September 12, 2017
Medway Planning and Economic Development Board
155 Village Street
Medway, MA 02053

Public Hearing Continuation - Paul Revere Estates Definitive Subdivision:

RE: **Public Hearing Continuation: Paul Revere Estates Definitive Subdivision Plan**
Continuation Date: Tuesday, September 12, 2017 at 7:00 p.m.
Location: Medway Town Hall – Sanford Hall, 155 Village Street

PAUL REVERE ESTATES
DEFINITIVE SUBDIVISION
COVER SHEET
PLAN OF LAND IN
MEDWAY, MA

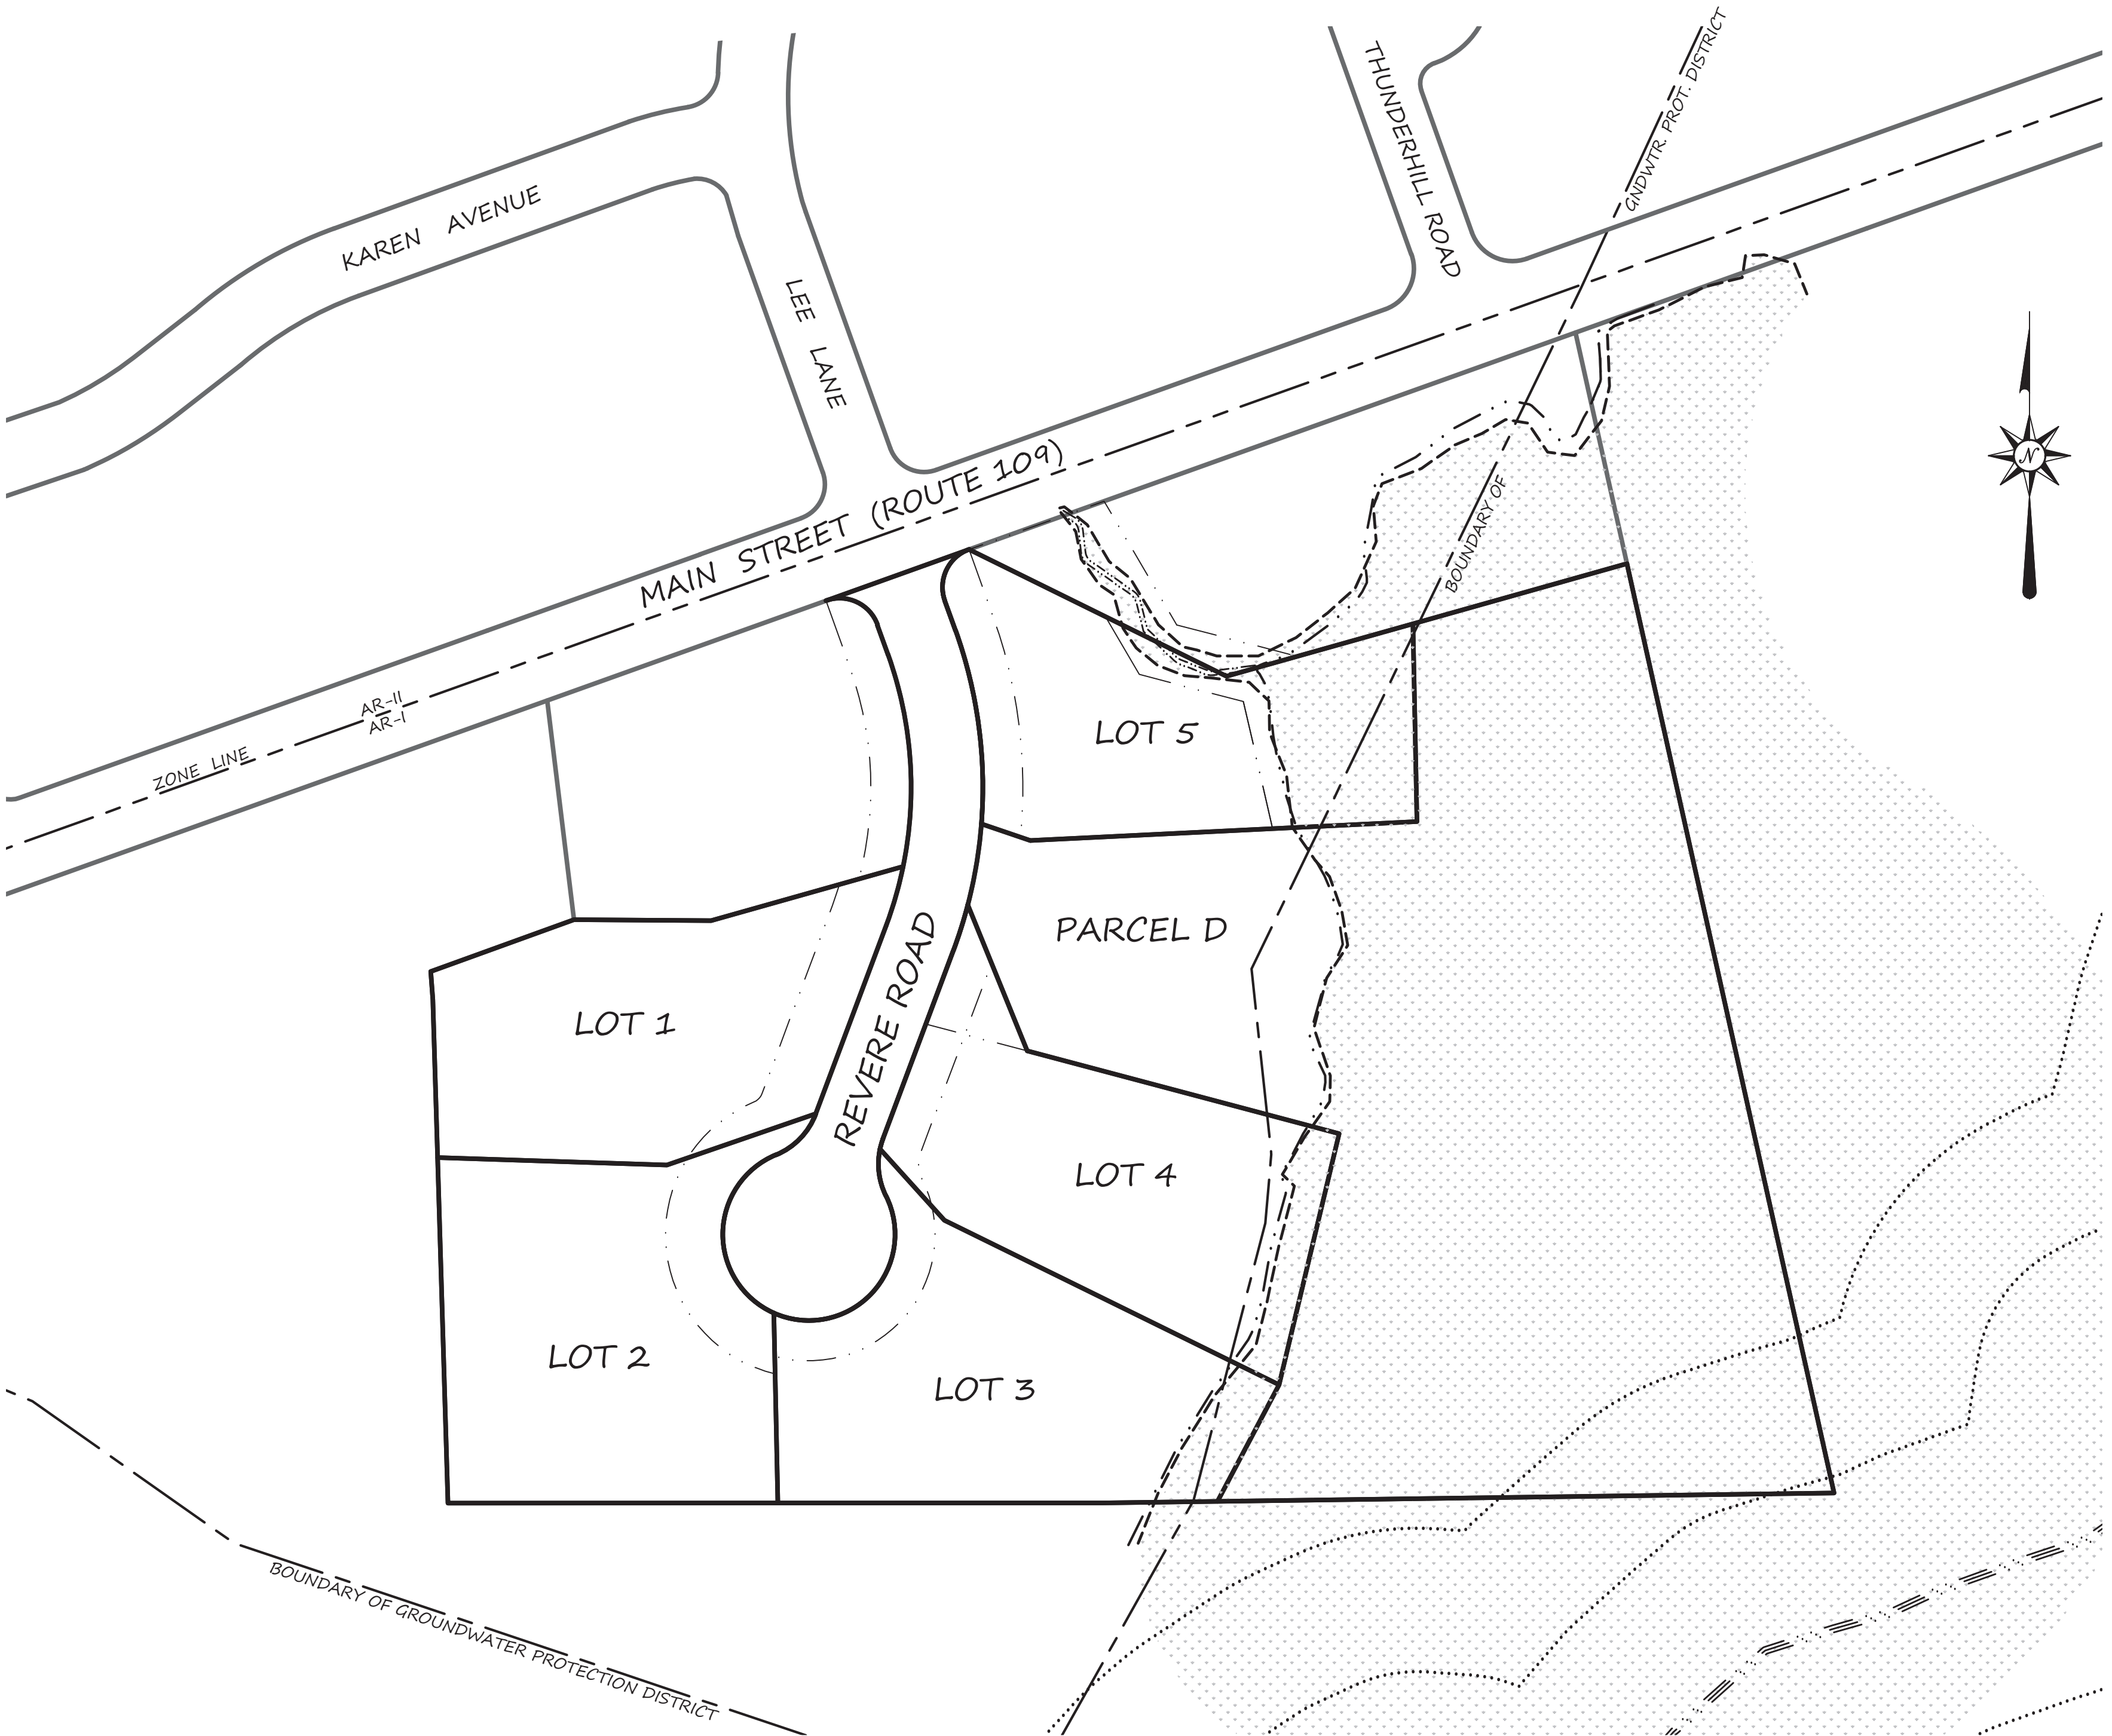
- As discussed with the Board, sloped granite curb has been replaced with monolithic cape cod berm within the subdivision and a detail for monolithic cape cod berm has been added to sheet 9. A waiver request has been added to the cover sheet and a waiver request form is attached to this letter.

D104-01 SHEET 7 OF 12

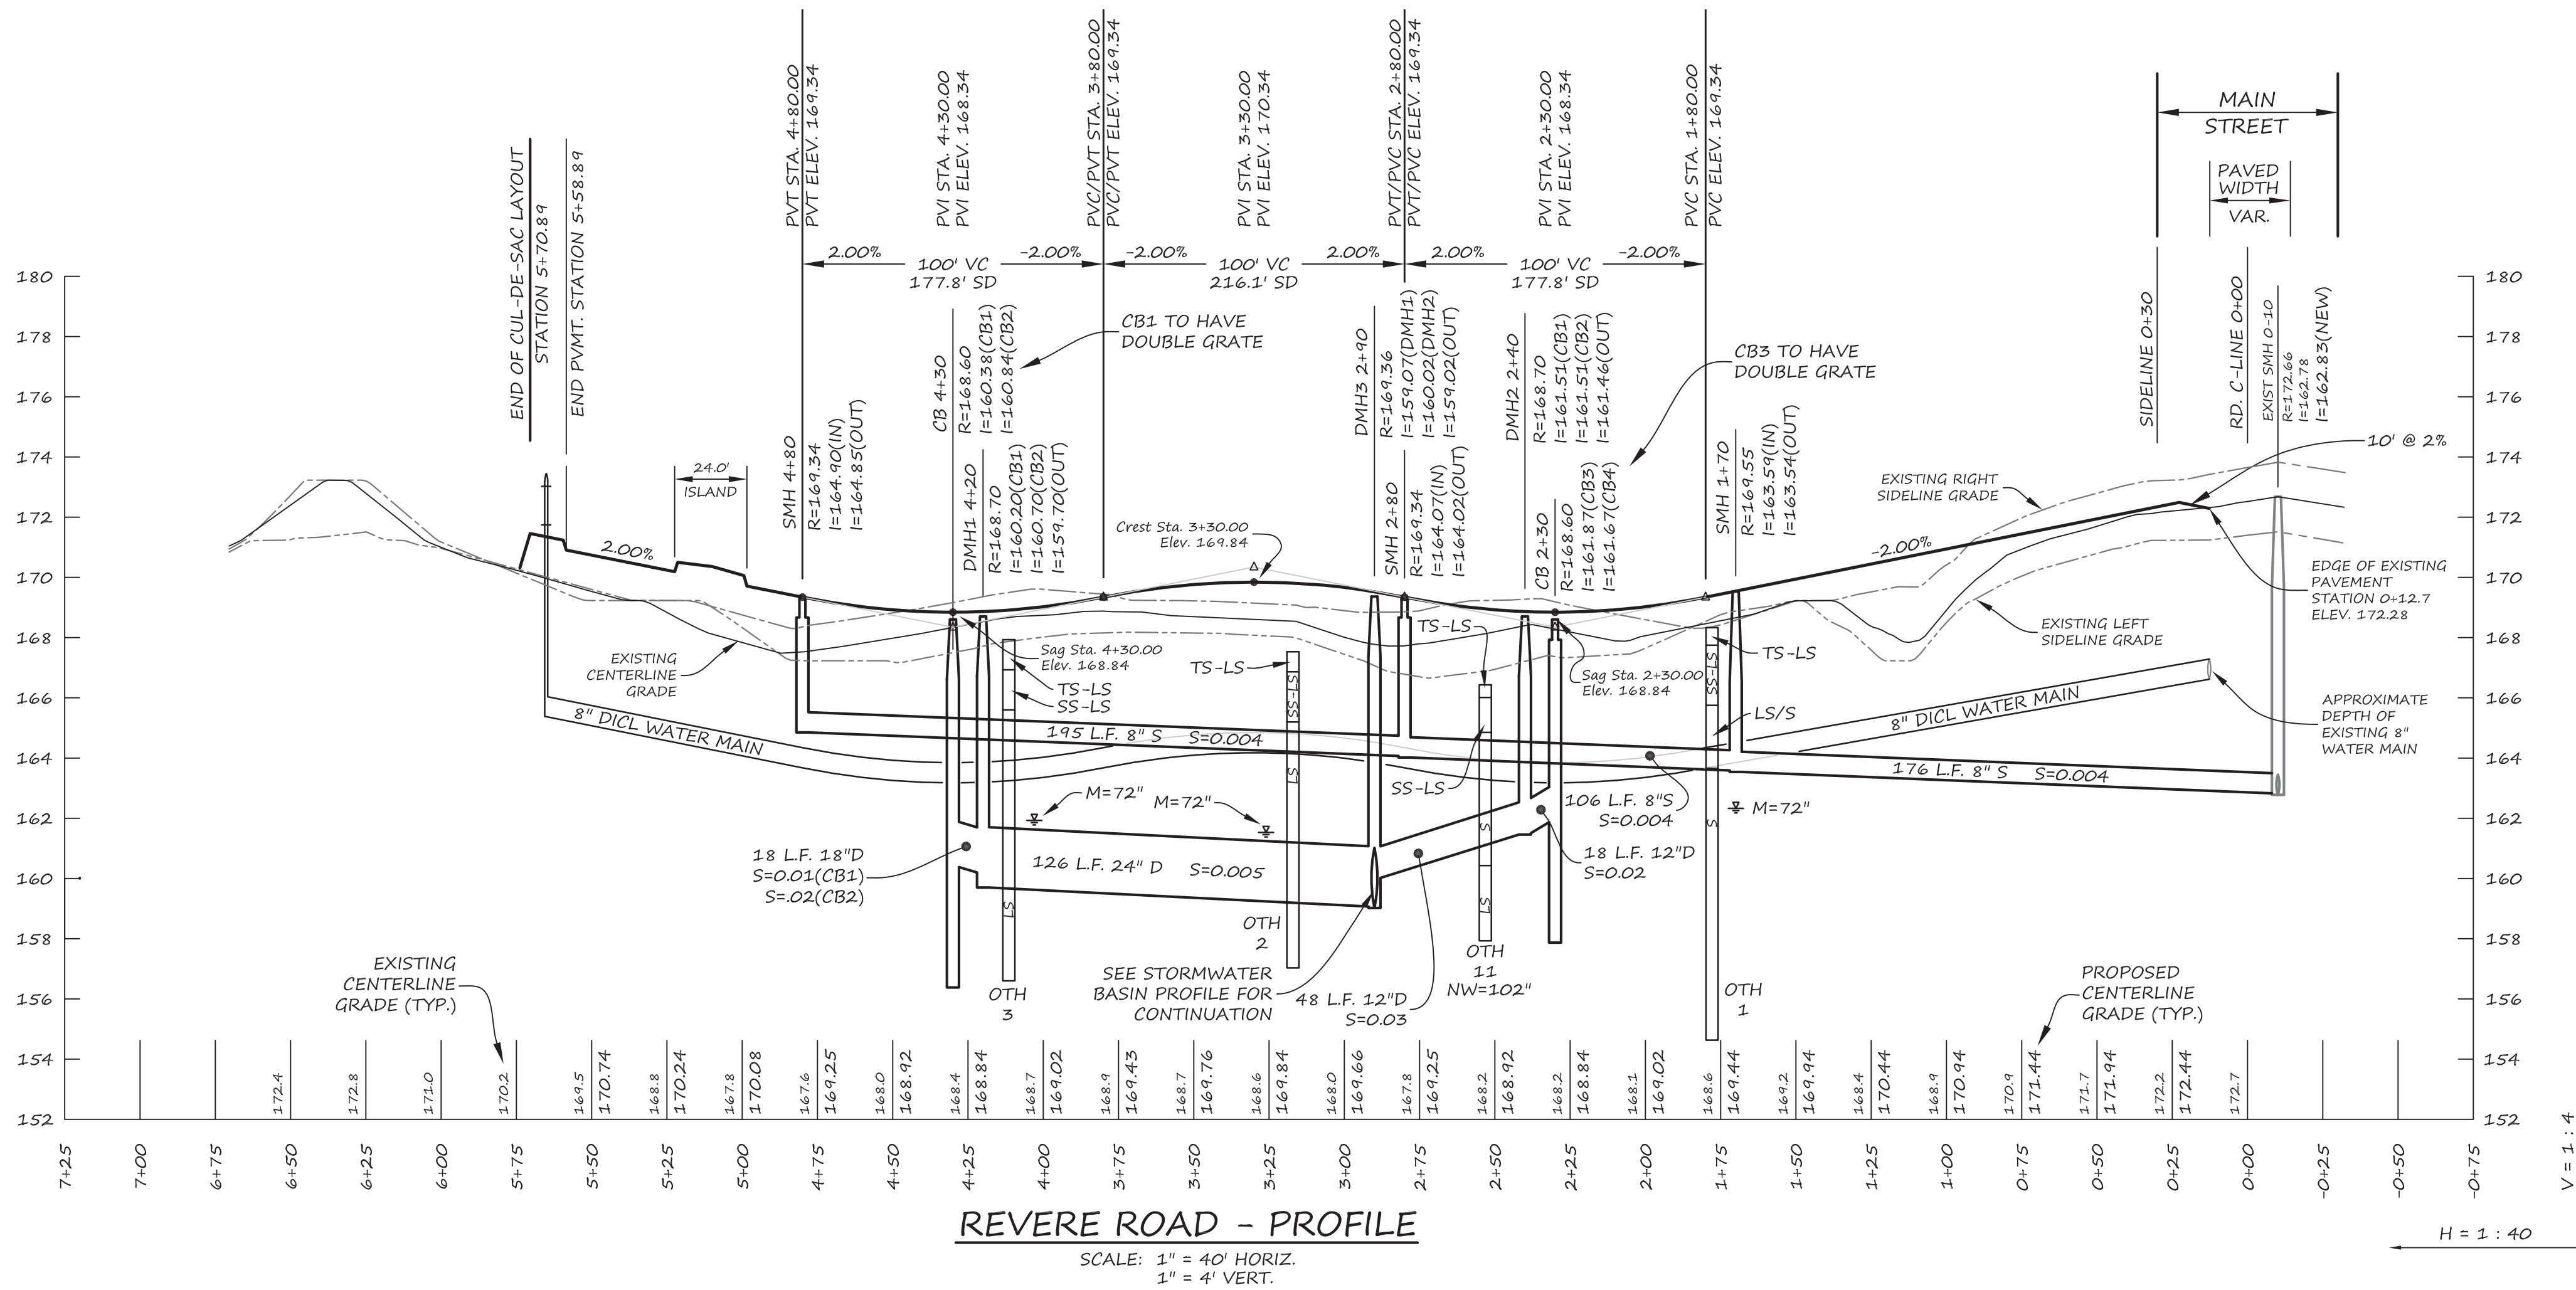
- As requested by the fire chief, the cul-de-sac pavement diameter has been returned to 50'.
- As requested by the police department, the street sign note on the plan view of sheet 7 has been changed to include both road name signs.

- As requested by the Police Department, a "Caution Children" sign at the entrance to the subdivision has been added to sheet 7.
- As requested by the Police Department, the plan view of sheet 7 has been revised to include "Crosswalk Ahead" signs along both direction of Main Street.
